ZBA 2022-29

Petition of Bank of America, NA  
342 Washington Street

#### ZBA 2022-29 BANK OF AMERICA, 342 WASHINGTON STREET

Subject: Bank of America Wellesley  
**Construction Change Narrative Letter**  
Project Number: 005.3722.000  
File Code: 5CD

EXISTING CHIMNEY REPAIR

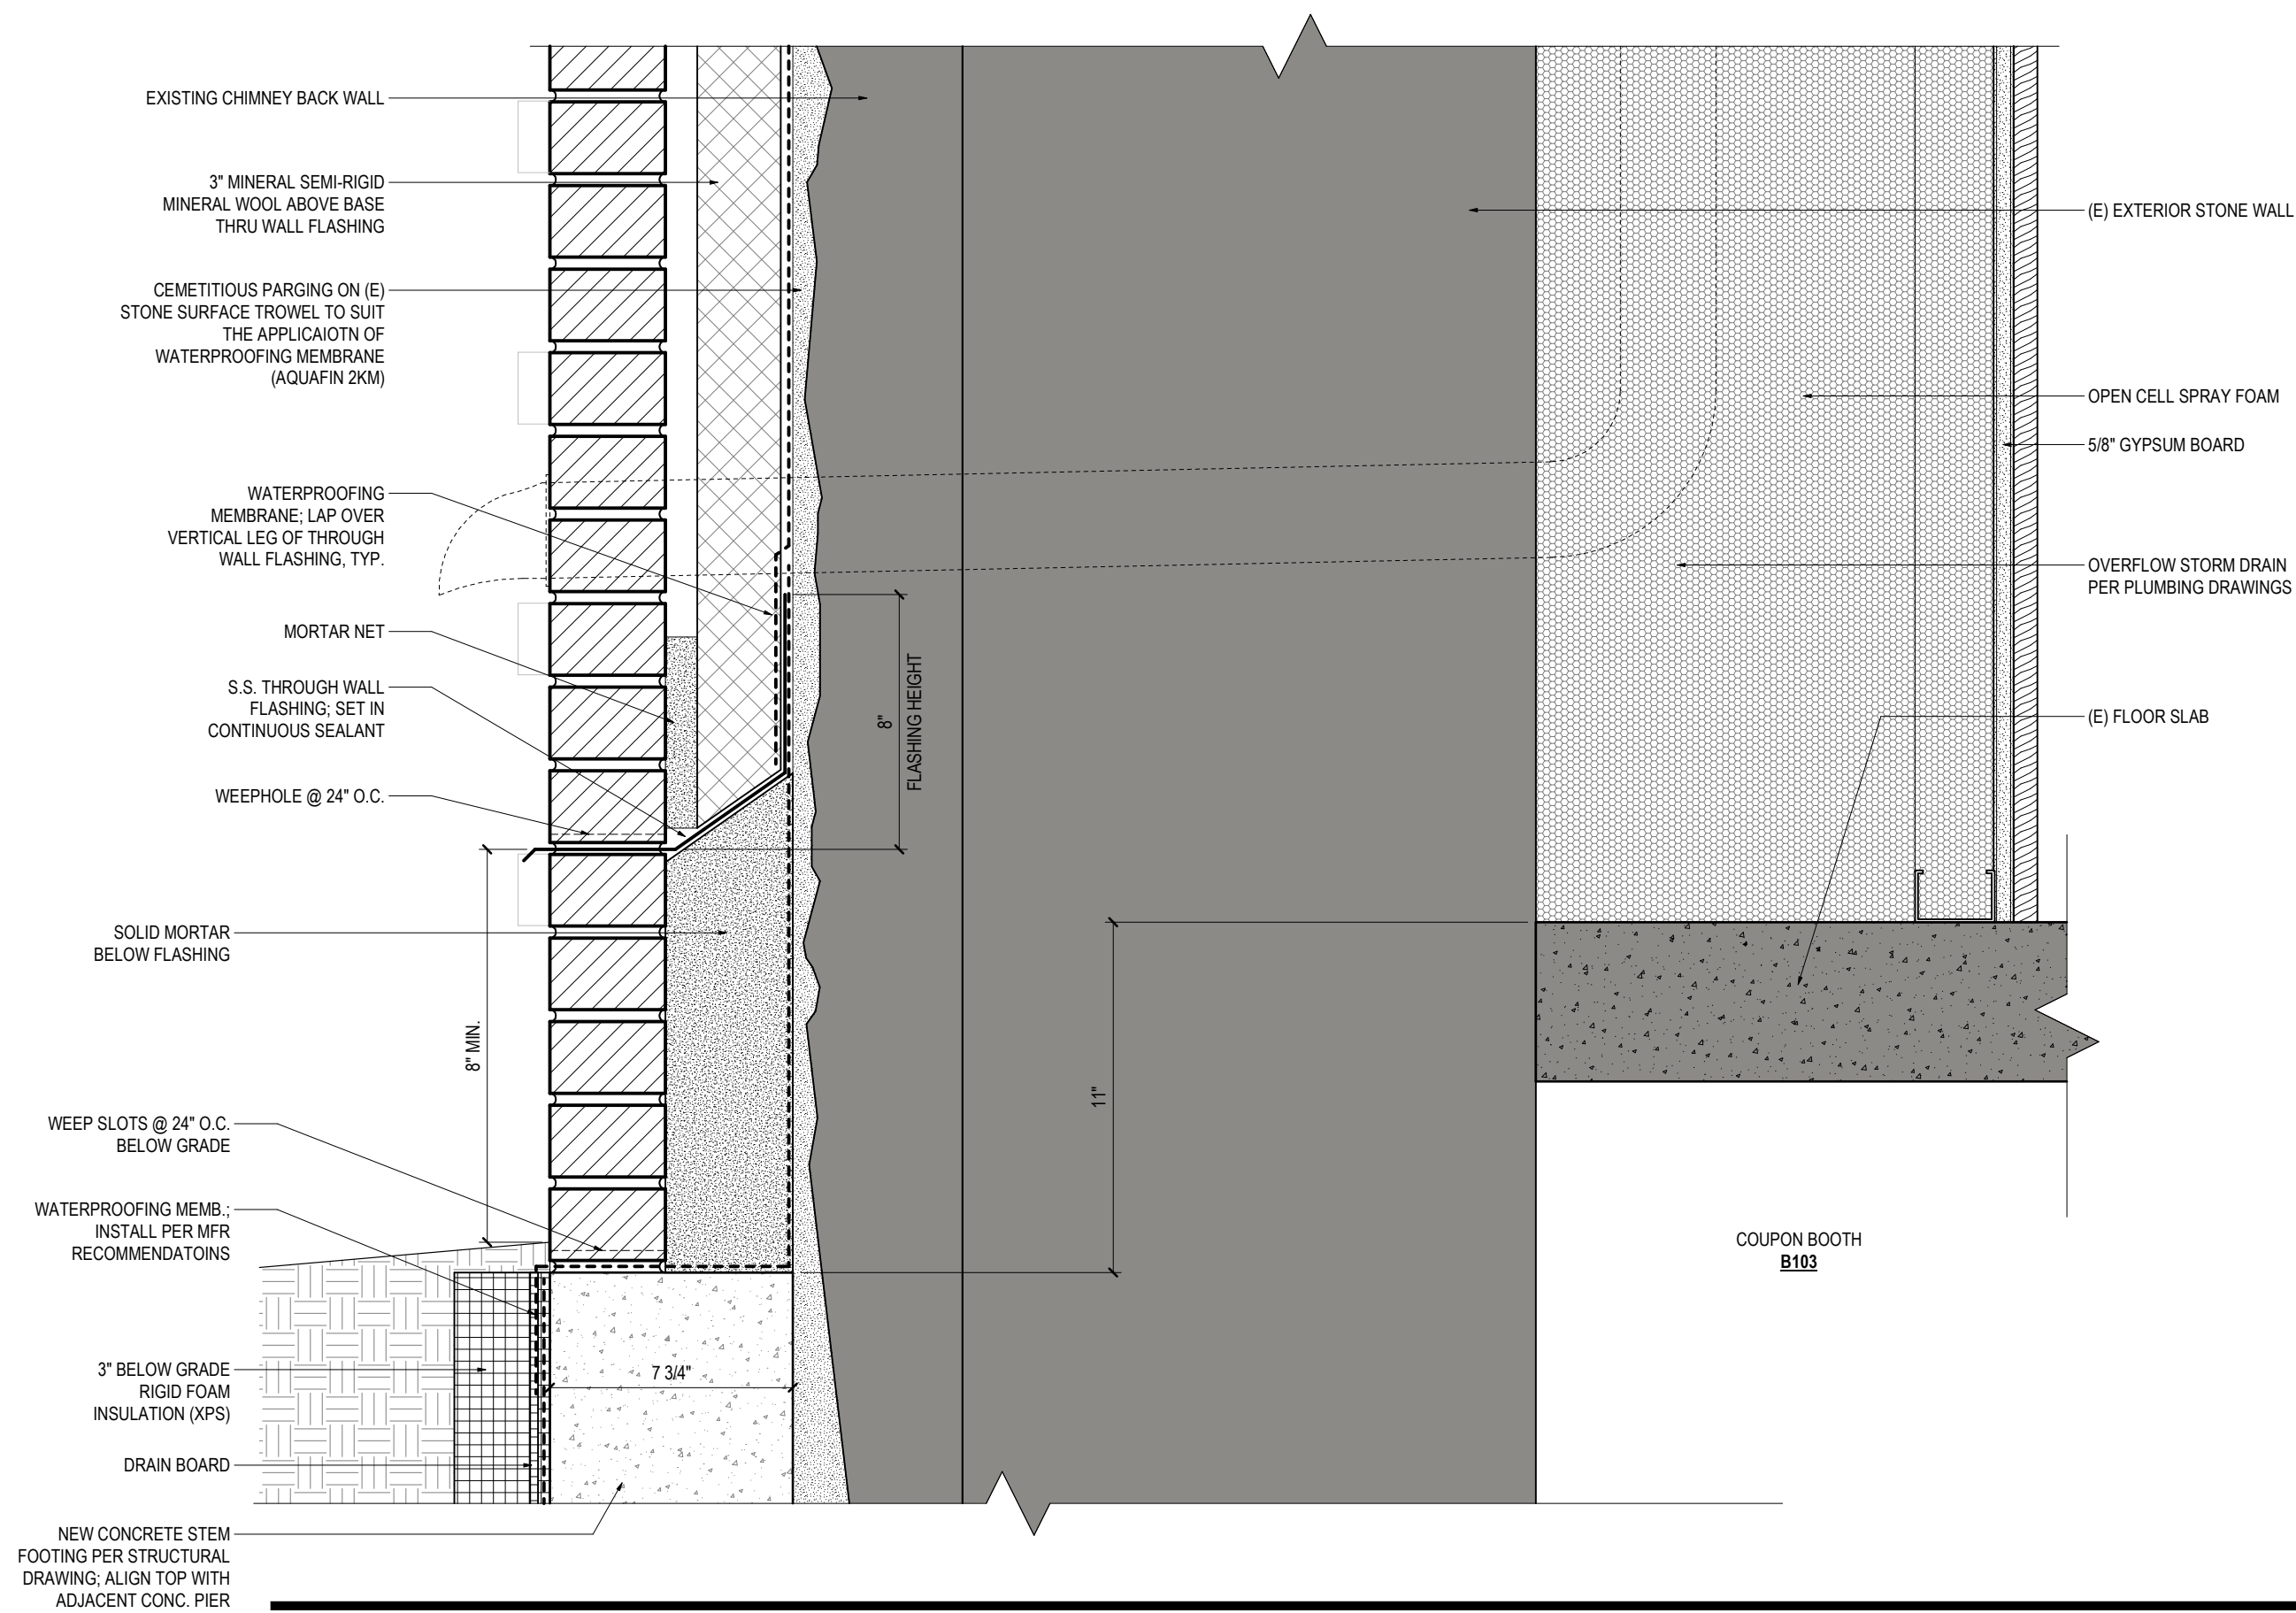
Mr. Adams said that Plan AR-03C shows the original chimney. He said that the chimney appears to be cut down or absorbed into the addition that shares the same gable roof. Ms. Reker said that they thought that they could remove the complete chimney but found during construction that it is integral to the wall. She said that they will remove the portion of the chimney that is above the eave line. She said that they will make the chimney architecturally fit into the existing adjacent addition. She said that the plan is to use the same brick as the addition. Mr. Levy said that he could not see any difference on Plan AR-03D between the originally proposed and the newly proposed with chimney repair. Ms. Reker said that it is a really small chimney bump out. She said that it is shown on Plan AR-03E in the middle top image.

3. **Chimney repair** – Due to the challenges encountered during construction, it is not possible to completely remove the stone of the existing chimney walls. As shown in the images on Appendix 'B', there is a 4" stone wall ledge that protrudes from the existing wall surface. Additionally, the inside face of the chimney wall remains unfinished and can't serve as an exterior wall finish. To achieve a refined appearance for the chimney area, Gensler proposes extending the new brick veneer over the chimney area to provide new wall finishes. For a visual representation, please refer to the rendering on pages AR-03D and AR-03E, as well as the elevation on pages AR-05. Furthermore, detailed information can be found on page AR-11 in the presentation deck.
